Cockle Bay Park Redevelopment State Significant Development Application (SSD DA) Stage 2

MOD-1 Envelope Modifications Proposal

Prepared for DPT Operator Pty Ltd and DPPT Operator Pty Ltd
01.11.2021

Podium North

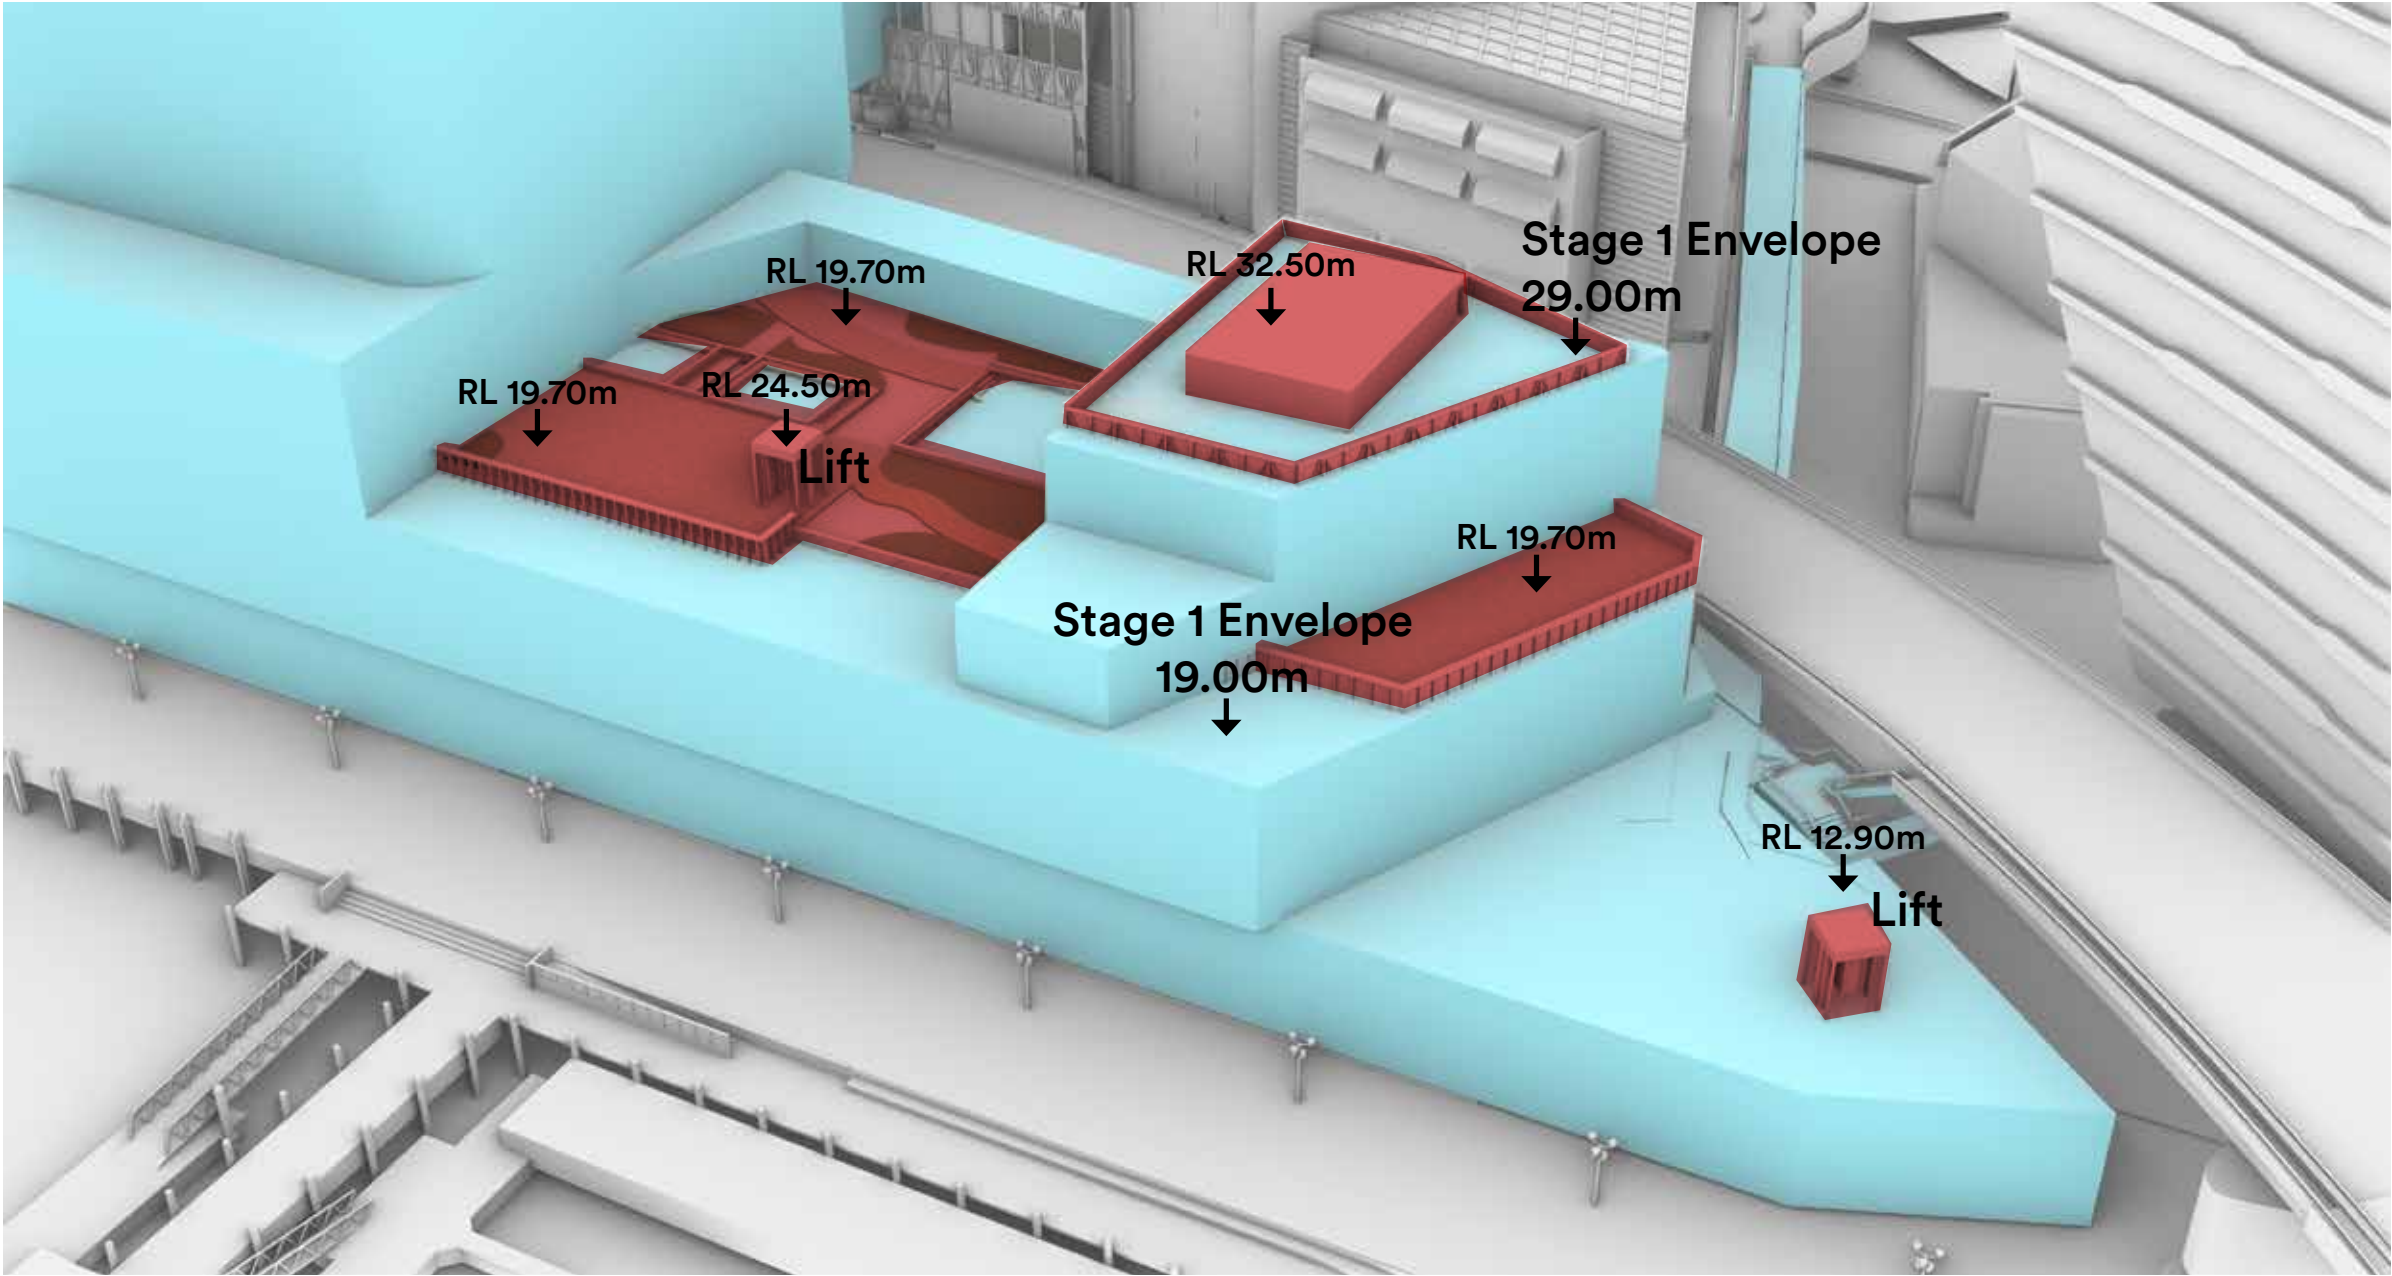
The updated scheme has pulled the built forms away from the Pymont Bridge heritage item as an improvement to the approved Concept Proposal and the competition scheme that had more built volume encroaching on this space.

This separation results in a more compact group of pavilions within the village forms of the podium, a new DDA compliant lift next to the Bridge and the northern circulation zone, and a generous ramp that connects Pymont bridge with Northern portion of the podium.

The proposed built form has been pulled back from the envelope in many areas, however the height of the building in this area has been adjusted to provide better amenity through functional floor to floor heights and enable greater flexibility in building usage in the future.

In order to facilitate equitable access to all public open spaces and retail tenancies, a number of lifts have been designed to support the circulation requirements of the Southern end of the podium. These elements will enhance the activation of the Southern park, improve the pedestrian movement along the Level 1 street and enable access to a special destination space above the park in the southern anchor tenancy.

The scheme now also includes the provision of stair access and kitchen exhaust plant spaces on the rooftop of the Southern podium volume. Stair access will allow the rooftop photovoltaic panels to be maintained. The height of these volumes has been minimised and are not deemed to adversely affect sightlines across the development or cause impact on the surrounding amenity.

Northern Park

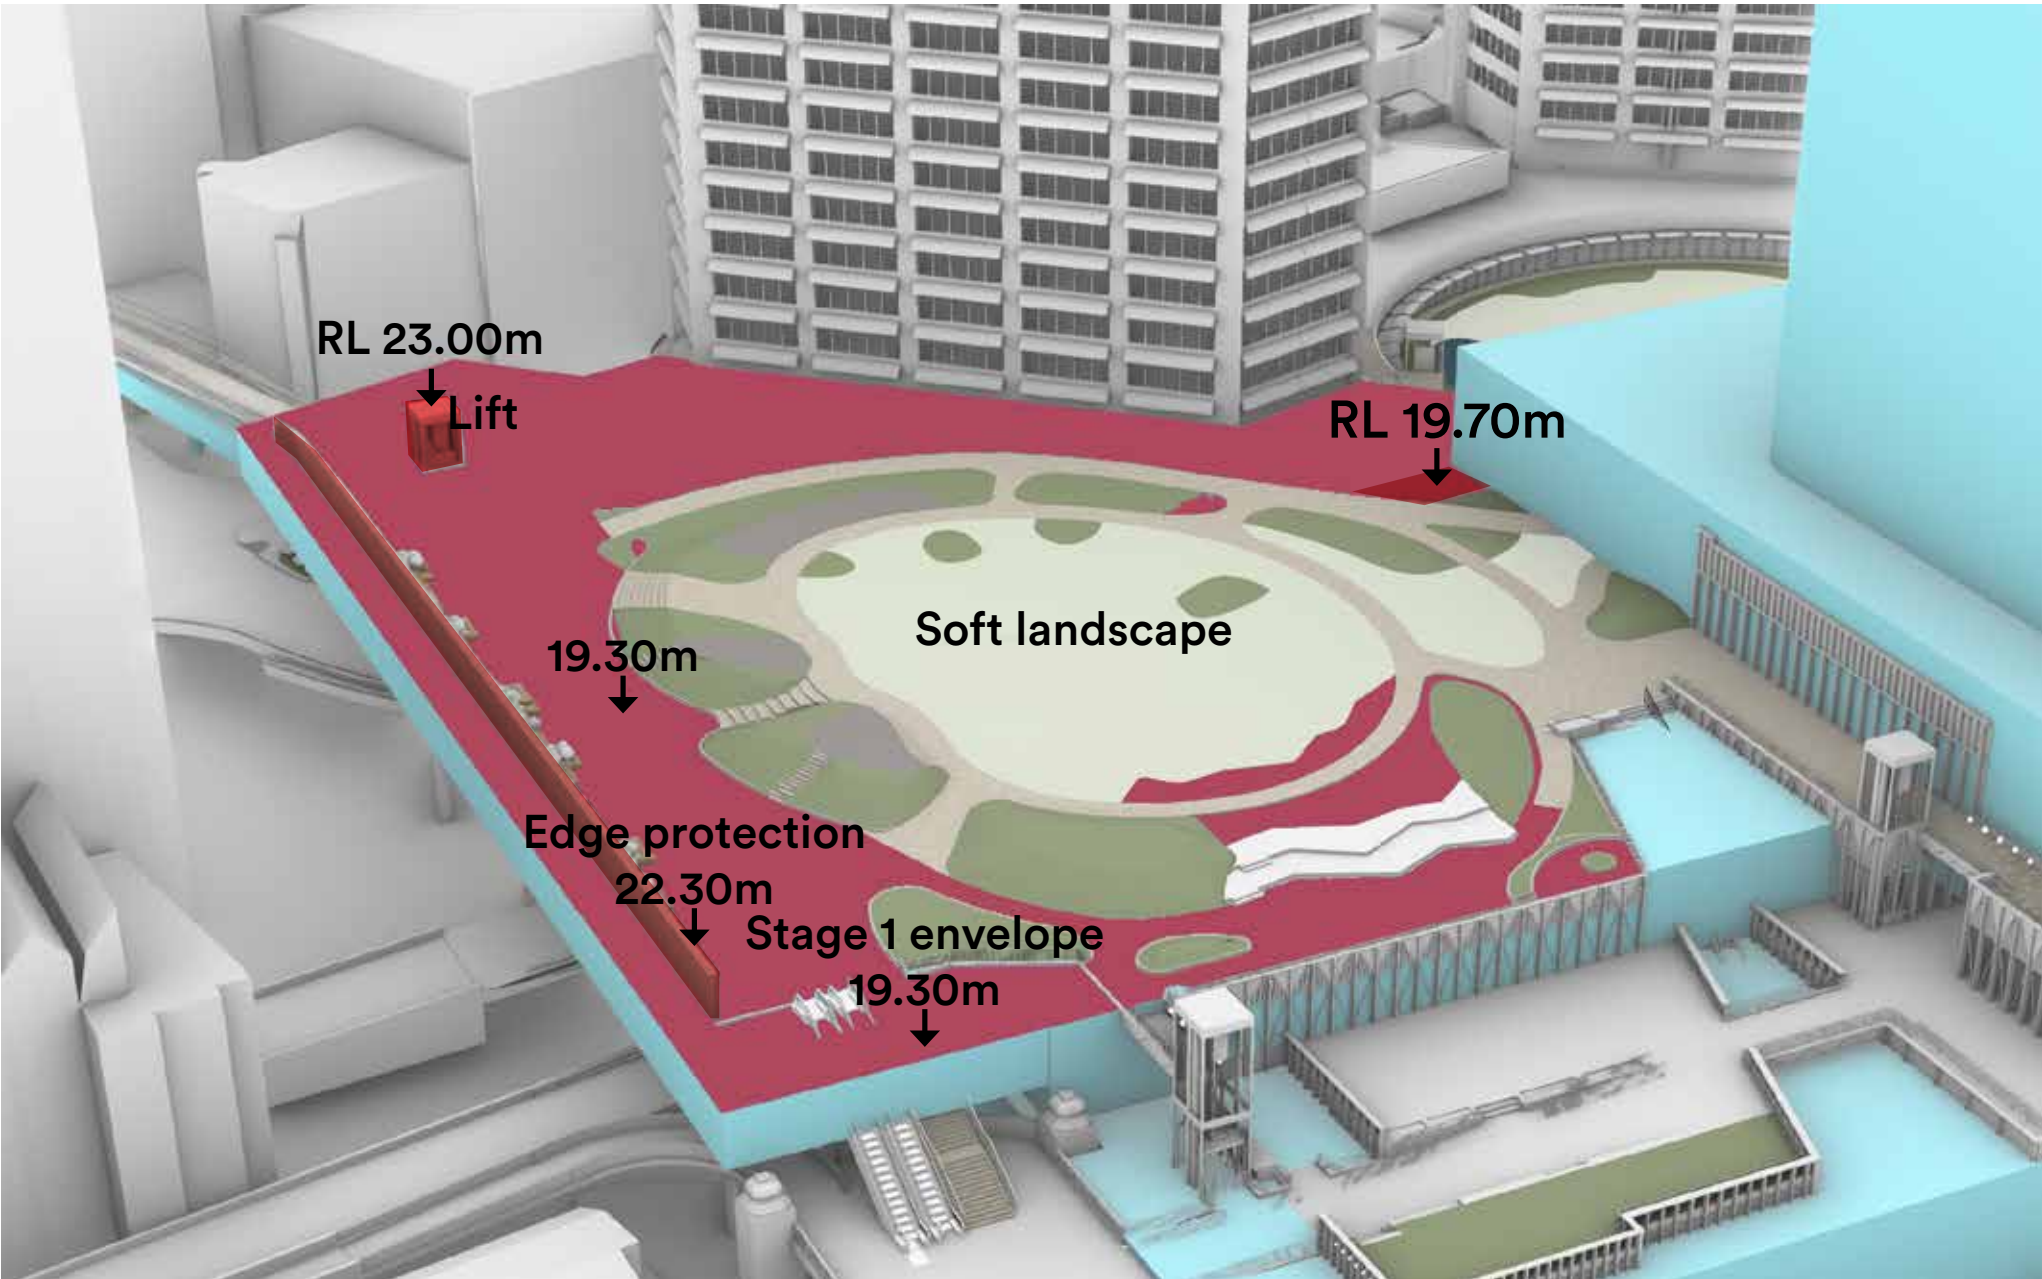
Refinement of the landbridge structure over the Western Distributor at the Southern end of the site has resulted in the finished floor levels of the Tower Lobby and surrounding external spaces being at a higher RL than originally envisaged. The landbridge, rises to 19.3m to allow clearance to Western Distributor roadway below.

Further, in order to provide sufficient soil depth for the desired planting, the landbridge deck's park landscape is increased at various amounts., This is detailed further in the clarifications section of this report.

A wall has been erected on the Northern edge of the park to provide protection to the Western Distributor below and is a requirement resulting from consultation with Transport for NSW (RMS) during the preparation of the Stage 2 SSD DA.

Pymont Bridge connection

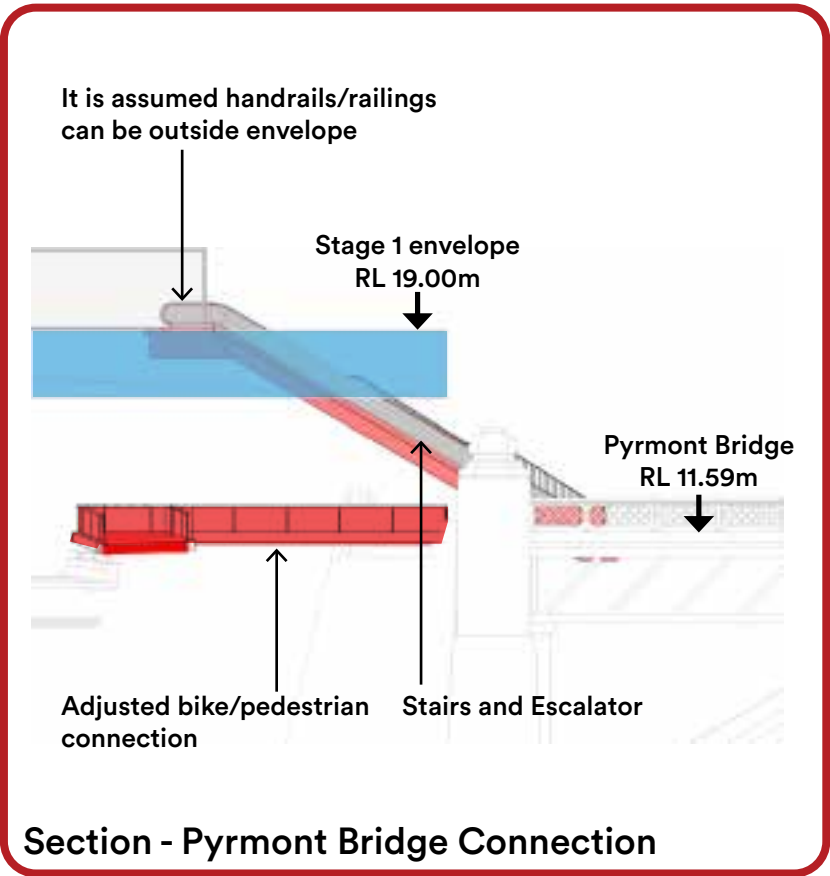
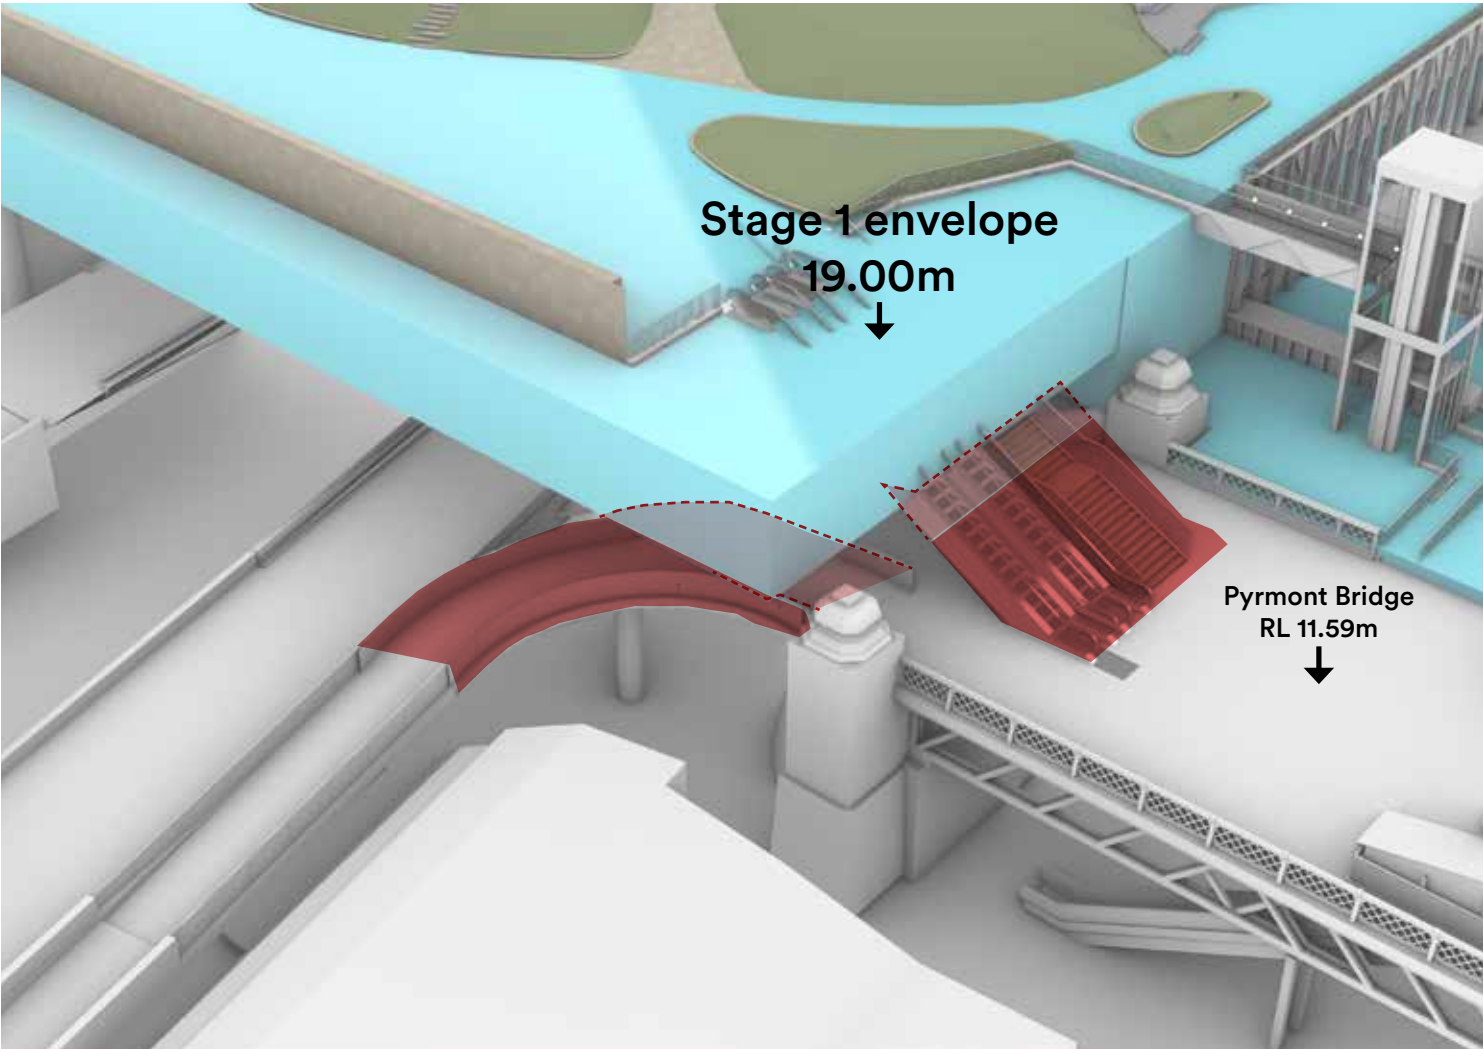
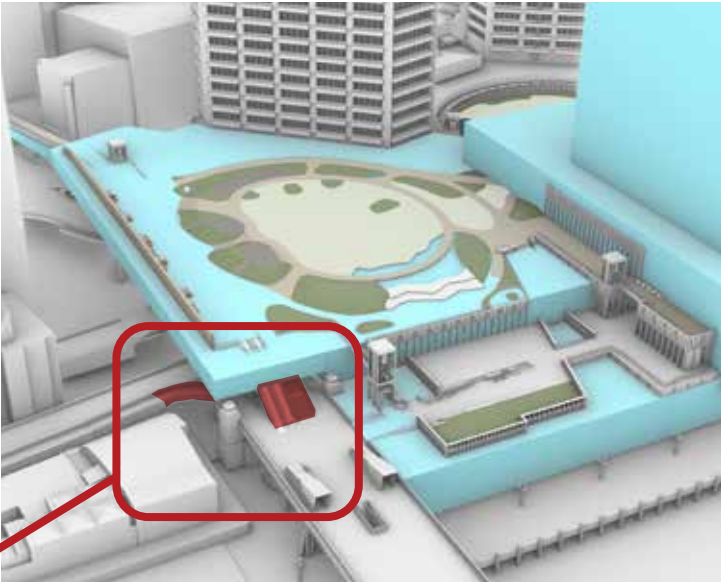
The Stage 1 DA approved envelope did not accommodate the pedestrian connection from the landbridge onto Pymont Bridge. Here, the addition of stairs and escalators, plus a realignment of the Harbour Street bicycle ramp connection, improves accessibility for pedestrians and cyclists in this area. These changes would be a positive impact on the overall project by enabling seamless pedestrian and cycle movements between Darling Harbour and the CBD through the site, connecting prominent, existing links to the new landbridge.
